S96 No: N0022/16/S96/1 RECEIVED MONA VALE Name ANNE ELLIS The Interim General Manager Northern Beaches Council Address 1158 BARREN JOEY RO 1 5 DEC 2016 PO Box 882 MONA VALE NSW 1660 PALM BEACH CUSTOMER SERVICE (Fax No: 9970 1200) Phone 9974-45271 Date 15 DECEMBER 2016 Proposed Development: Modification of consent N0022/16 for the demolition and construction of a new dwelling house and alterations to existing garage and landscaping. 1156 BARRENJOEY ROAD PALM BEACH NSW 2108 At: I have inspected the plans and related documents. I have considered them in the Yes context of the relevant planning instruments or policies. I am willing to provide expert reports to supplement my comments should a conflict in opinion arise. am willing to provide evidence to the Land and Environment Court if the application is appealed. In the interests of public transparency please note that your submission in its entirety will be available to the applicant or other interested persons on request and will also be made available on Council's internet site through Council's transparent Development Application Tracking process. You are encouraged, as is the applicant, to discuss with each other any matters that

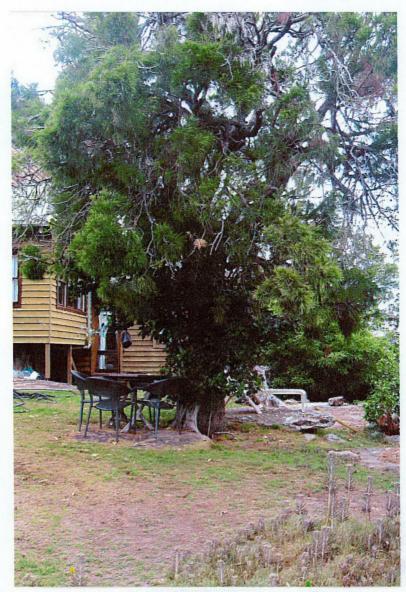
It was specified in early plans that the wall around the seating (described as the 'terrace wall' on 1501-P-4 rev. c) was to be screened either by the 'existing' or else planted vegetation. It may already have been noted that there is no existing vegetation there and that the earth is only a centimetre or two deep. Are there any plans now to screen the wall with vegetation? Or will it remain a bare wall? As stated above, the location of the wall within the root zone of the casuarina may well seriously affect the heath and survivability of this tree. The shallow soil will also prevent the placement of vegetation to visually reduce the built form. When combined, the total effect will be a reduction in vegetation and an unsightly wall close to our private open space. The paving around the seat would also prevent infiltration of water and increase runoff, to the detriment of the surrounding vegetation. It should be noted that if the 'terrace wall' in dotted format on 1501-P-04 rev. d and presumably some seating (not shown) is in fact not intended to be there, then this is an observation rather than an objection.

(1) Shows casuarina tree and our table on the small rock platform beneath it. The photo also illustrates how close the 'terrace wall' in its present dotted form would be to the tree.

(2) Shows the drip area of the casuarina on its western side. (Note: its branches extend to the top right hand corner of the photo.)

(3) Shows the thinness of the soil and how relatively narrow is the strip of land where the 'terrace wall' (in its dotted format) would be located, and how close it would be to our existing seating.
